MEETING MINUTES

To:	File	Date:	December 23, 2016
From:	Susan Vutz, Clarence Mamuyac	Project:	SMCCCD Cañada College B1N, Kinesiology and Wellness Building
Subject:	SD Meeting No. 3 – Faculty and Staff Input	Project No:	201619.00
Meeting Date:	December 15, 2016	Location:	CSM Building 1, Rm. 244
Attending:	<u>SMCCCD/Cañada College:</u> Chris Strugar-Fritsch (CS), Michelle Marquez (MM), Jose Nunez (JN), Gregory Anderson (GA), Nick Carr (NC), Cindy Jimenez (CJ), Anniqua Rana (AR), Erik Gaspar (EG), Ana Miladinova (AM), Doug Hirzel (DH), Katie Osborne (KO) <u>Swinerton:</u> Greg Cheifetz (GC), Jack Herbert (JH) <u>ELS/Blach:</u> Clarence Mamuyac (CM), Susan Vutz (SV), Ken Schroeder (KS)	Distribution:	Greg Cheifetz, Jack Herbert, Design Team

CAN B1N
SCHEMATIC DESIGN UPDATE #3 – 12.15.2016

L1 47,950 SF
GROSS BUILDING AREA
(INCLUDES ENTRY LEVEL)

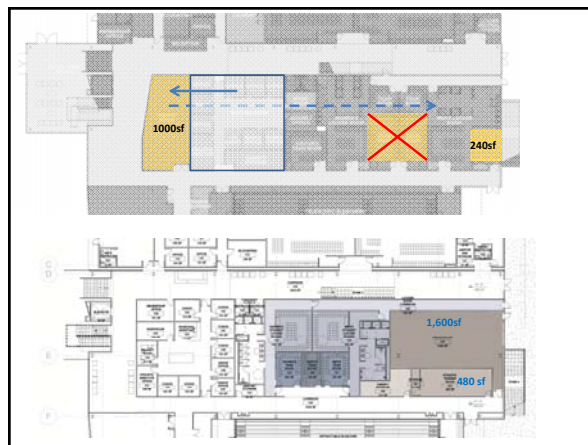
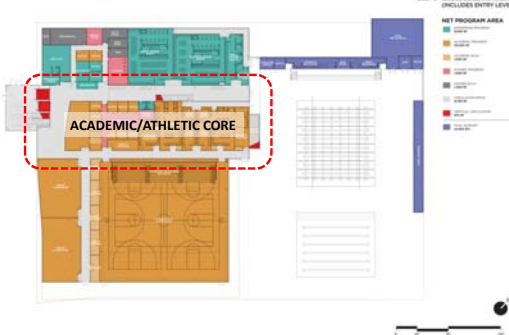
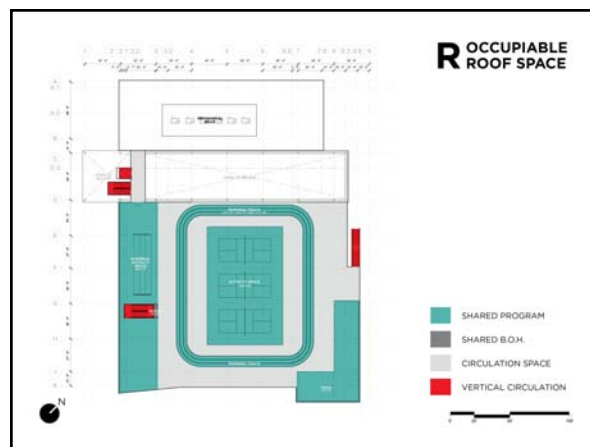
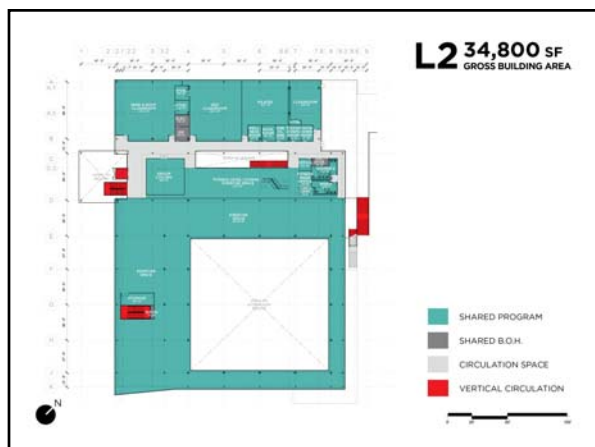
2.4 Shared Team Rooms: There is not enough space in the building to create four separate team rooms, however, coaches prefer not to share team rooms. It may be possible to create separate areas for two teams within one team room. Per JN, the building cannot be enlarged to create more space for team rooms.

2.5 Varsity Storage: It is possible to create two larger team rooms by dividing the varsity storage and giving half of the space to each of the team rooms, keeping the visitor's team room in the location shown.

3.1 Dance Studio Storage: Need storage for yoga blankets, blocks, stability balls, yoga mats, foam rollers. This should be inside the studio rather than in the hallway. A ballet barre will also be needed along one wall. **AM will provide a list of equipment needing to be stored to ELS so storage can be designed.** Storage might be shared between the two studios, or be located along the wall between the two studios, adjacent to the stair.

3.2 Athletic Trainer Office: Add glass to provide a view from the Athletic Trainer Office into the Athletic Training Room. Add a second door from the Athletic Trainer's Office into the faculty office area.
